SERVICE INFORMATION NO. SI 20E-004

Rotax Alert Service Bulletin ASB-912 i-007
ATA-Code: 24-20

Checking of the correct positioning of sealing plug in ignition housing for ROTAX® Engine Type 912 i (Series)

Fig. 1
Sealing plug in ignition housing

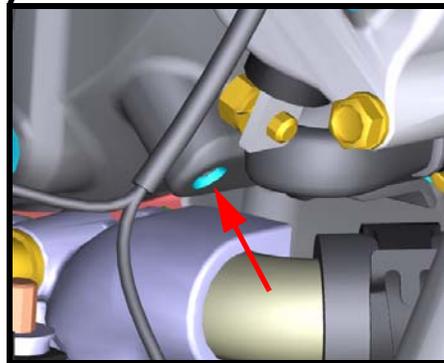
Field observation has shown that in isolated cases the sealing plug (see Fig. 1) was not pressed to its correct seating position in the ignition housing. In rare cases this may lead to loss of oil and subsequently loss of lubrication which leads to engine stoppage.

Fig. 2
Good/bad comparison of sealing plug position

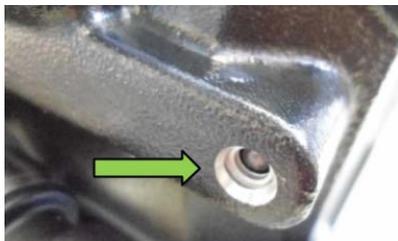
Step	Procedure
1	Check the position of sealing plug in the relevant area of ignition housing assy. See Fig. 2.
2	The sealing plug must show to have been pressed in until the top of the ball is below the edge of the sleeve. See position OK in Fig. 2.
3	If you notice sealing plug position is OK, then there is no need for further procedures. NOTE: If you notice sealing plug position is NOT OK, then see section 3.2.

Fig. 3
Correcting the sealing plug position with special tool (insertion jig)

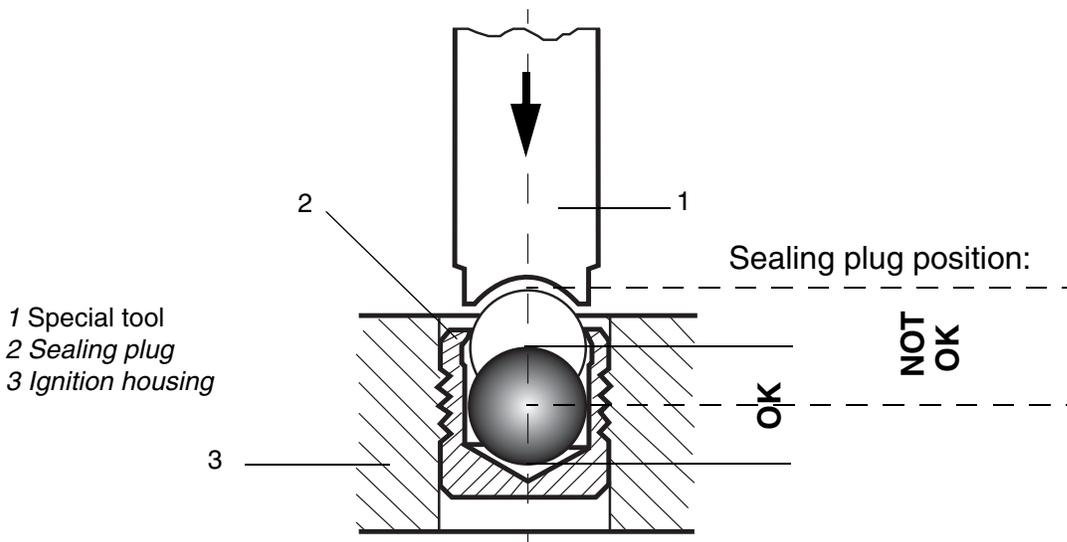
3.2) Correcting sealing plug position (required if position of sealing plug is incorrect, see Fig. 2)

Step	Procedure
1	<p>Correct the sealing plug position with a hammer (max. 300 g / 0.66 lbs) and the relevant insertion jig part no. 676255 as per section 2.6. Intuitively control your manual insertion force just to set the ball in correct position. See Fig. 3.</p> <p>NOTE: The bore must be free of oil, grease and chips.</p> <p>NOTE: Make sure to insert the insertion jig in correct alignment of the center bore / center line of the sealing plug.</p>
